**UNITED STATES OF AMERICA
NUCLEAR REGULATORY COMMISSION**

)	
In the Matter of)	
SOUTHERN CALIFORNIA EDISON COMPANY)	Docket Nos. 50-361-CAL & 50-362-CAL
(San Onofre Nuclear Generating Station,)	ASLBP No. 13-924-01-CAL-BD01
Units 2 and 3))	January 9, 2013
)

GUNDERSEN AFFIDAVIT

Figure 1

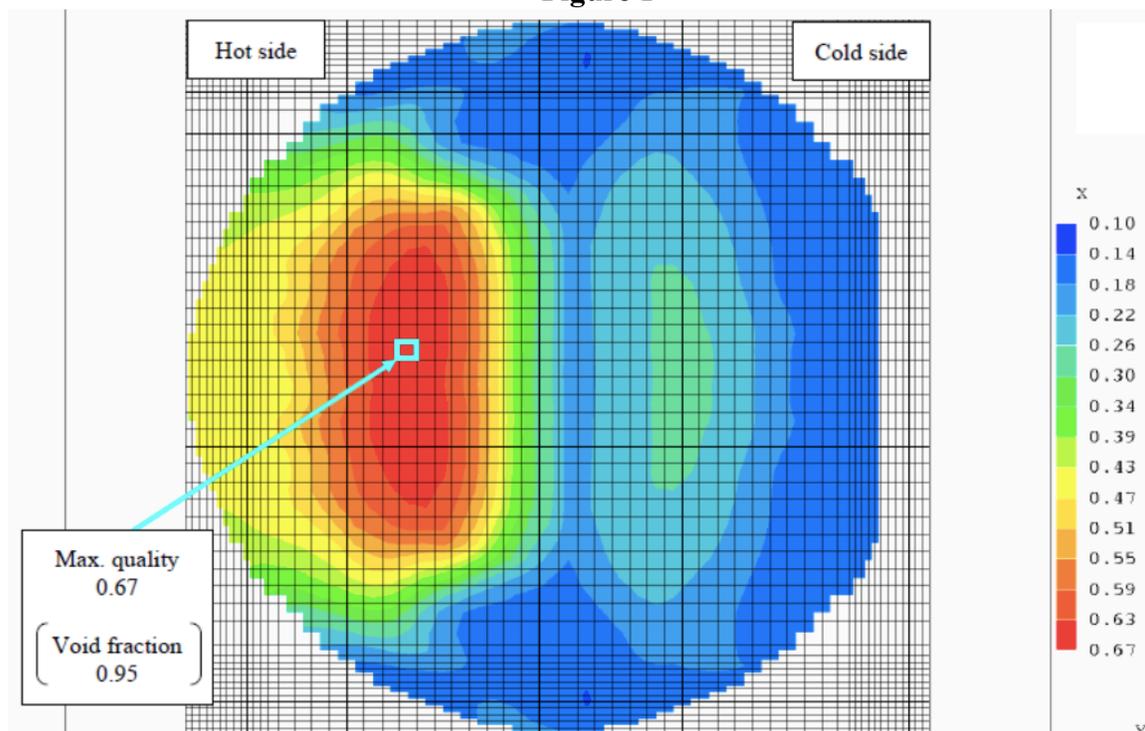
61. Fairewinds review of Figure 1 below from Edison’s Condition Report clearly shows that the location within the steam generators where the steam “fluid elastic instability” has developed is precisely the region where the extra heat created by the 400 new tubes would create an excess of steam and various vibrational modes.

64. This data shows that a significant quantity of additional heat has been transferred to an area that previously had no tubes. That heat must be removed from this central area, yet Edison also reduced flow by replacing the egg crate supports with broached supports.

65. These design changes by Edison created too many steam bubbles that are causing various vibration modes and degradation in all four steam generators.

66. The data reviewed shows that the decision by Edison, to add almost 400 tubes to the center of the four Replacement Steam Generators, changes flow patterns by removing the stay cylinder. This decision by Edison also reduces flow by removing the egg crate tube supports and created the excess heat that is the causative factor in the fluid elastic instability in the Replacement Steam Generators at San Onofre.
